ALL DIMENSIONS IN MILLIMETERS UNLESS OTHERWISE NOTED 0.1 ± 0.1 0.01 ± 0.01 0.001 ± 0.001			
PART NAME: Medium Hub - Holes		REV: B	
P/N: C003-07		DATE: 11/29/16	
DRAWN BY: D. Wenzel		2:1	
Aluminum 6061 - Anodized

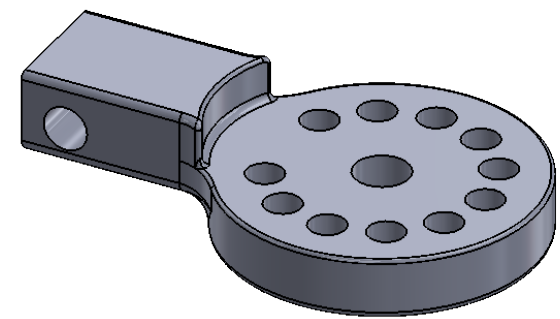
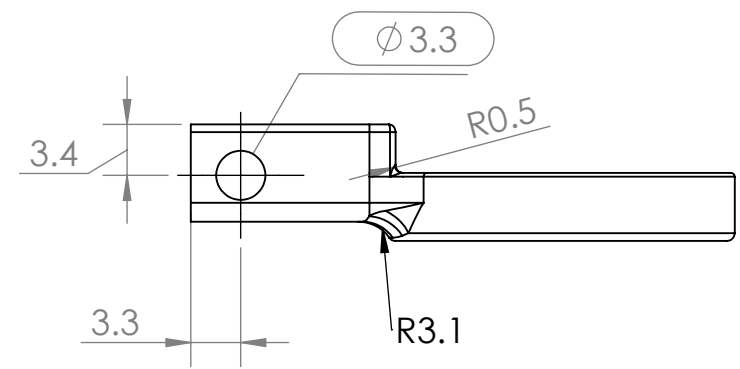
REV	CO#	DESCRIPTION	NAME	DATE
A	001	Initial Release	DW	8/10/16
B	002	Increased width of hub to improve machining. Tightened tolerance on center rivet hole. Increased size of ROM holes, decreased the number. Moved ROM holes away from the edge of the part. Added radius to box interaction. Added radius to transition from round to square geometry. Added width to box interaction, added material over round portion of hub.	DW	10/20/16
